Access Compliance Report Public Rights-of-Way (Curb Ramps)

Main Street: N/A		Cross Street: FLINTRIDGE_AVE		Location:	W
ADA ID: RPAT220125091415	Ramp Type: Type 4 - Parallel	Initial Pass/Fail: Fail	Overall Compliance: No	Severity Score:	2
Codes/Mitigation Info/Possible Solution			Field Measurements/Component Compliance

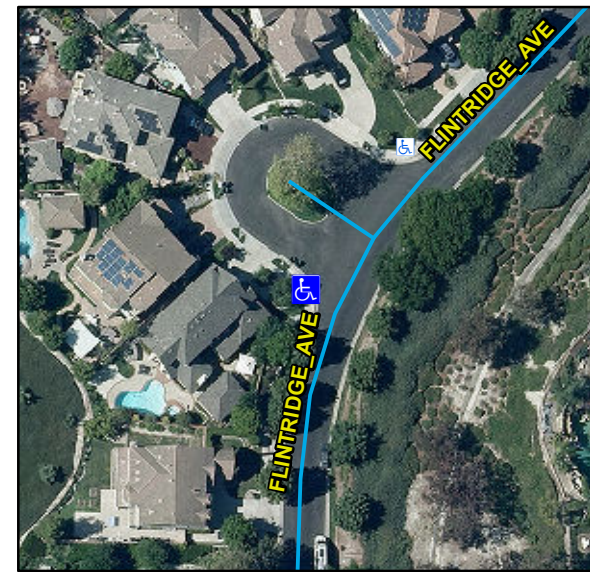
R204.3, R304.5.3, STD 1115

Remove & Replace Entire Ramp.
